Report to	Planning Committee
Date	10 March 2022
By	Director of Planning
Title of Report	Response to National Highway's Section 42 Statutory Consultation on the A27 Arundel Bypass
Purpose of Report	To update Planning Committee on the SDNPA's draft response to the A27 Arundel Bypass consultation

A27 Arundel Bypass Statutory Consultation Section 42(1) (b) of the Planning Act 2008 and Regulation 13 of the Infrastructure Planning (Environmental Impact Assessment) Regulations 2017

FIGURE 2-1 (SHEET 2 OF 6)

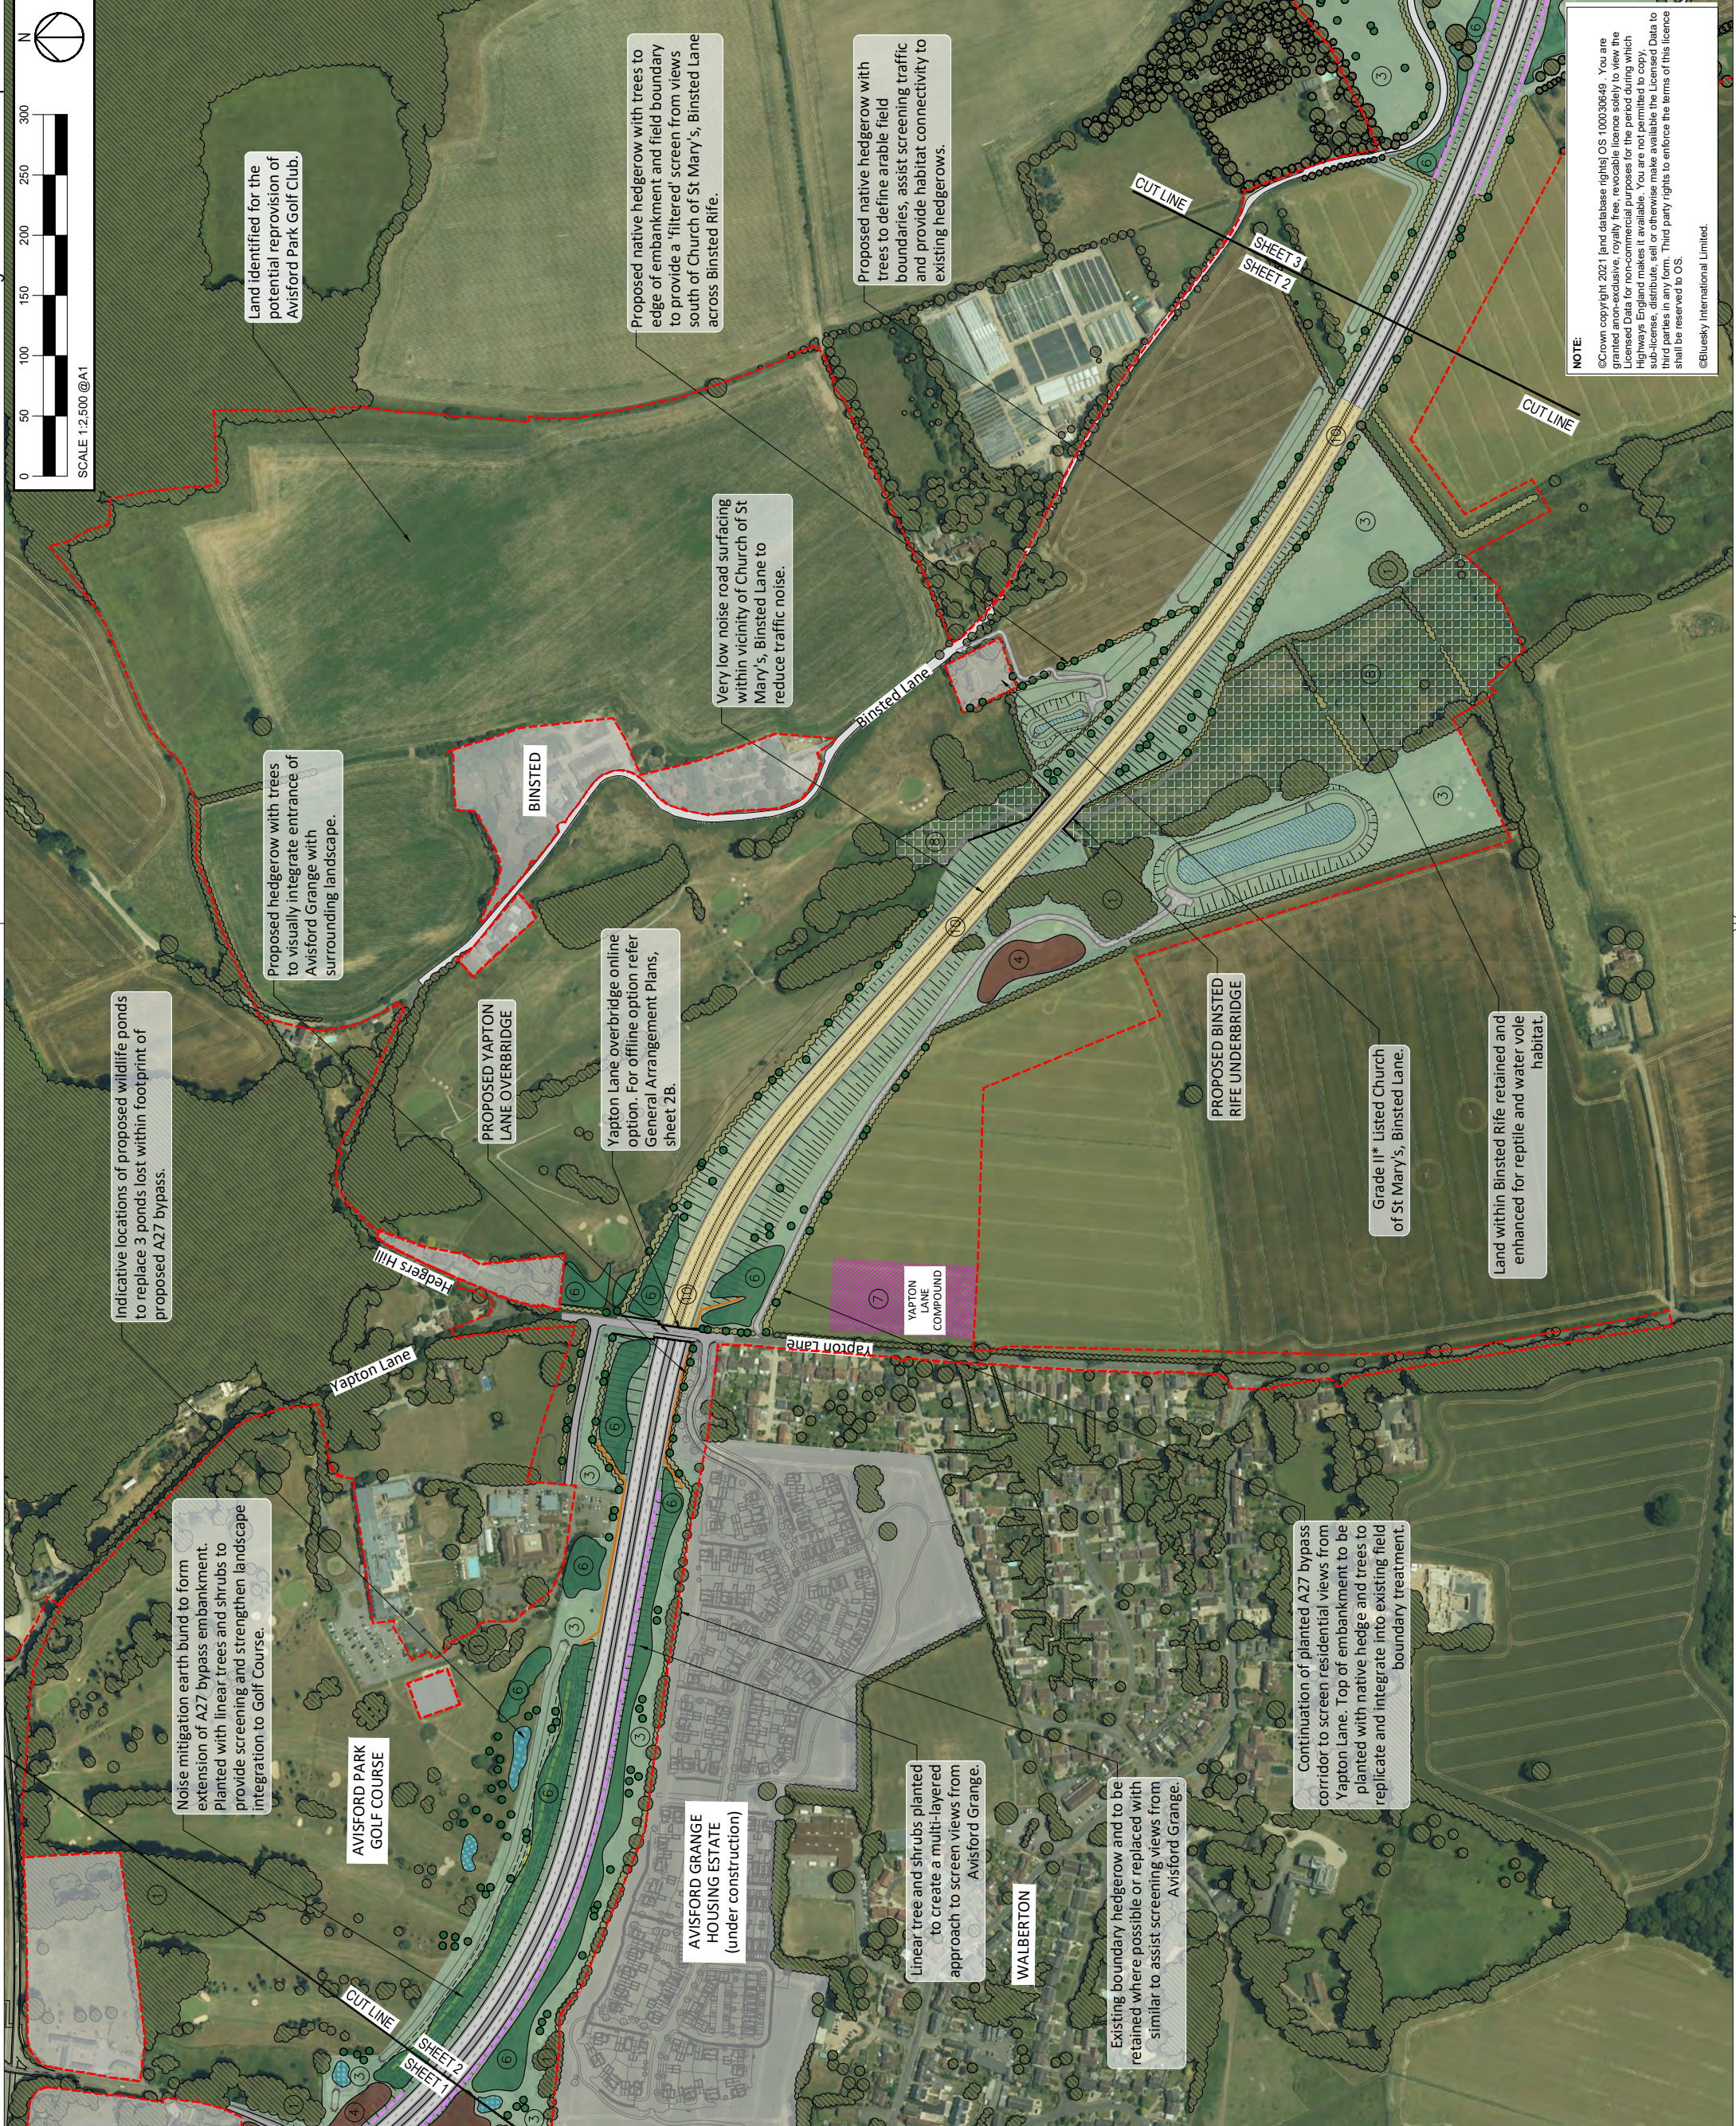
Ref	SDNPA Comment
Figure 2.1	Further clarification required regarding why the red line is within the National Park in this location.
General Arrangement Sheet 4	Where the bypass crosses over Ford Road the design of the road must be sufficient to accommodate a min 3m usable footway/cycleway on either side to future proof in consideration of the Arundel to Ford cycleway for which a study and revised business case are underway.
Volume 4	Appendices
App 7A para 3	There is no reference to the rarity and historic value of the ditches. No reference to the Historic Landscape Character – this is likely to result in under-assessment of the impacts on the landscape.
App 7A para 16	There is an area of Ancient Woodland within the Order Limits (and SDNP boundary) – please update statement.
App 7A para 86	As the scheme has updated, it is apparent that it is not just the de-trunking which is within the National Park boundary – please amend and be clear on what works will be within the National Park.
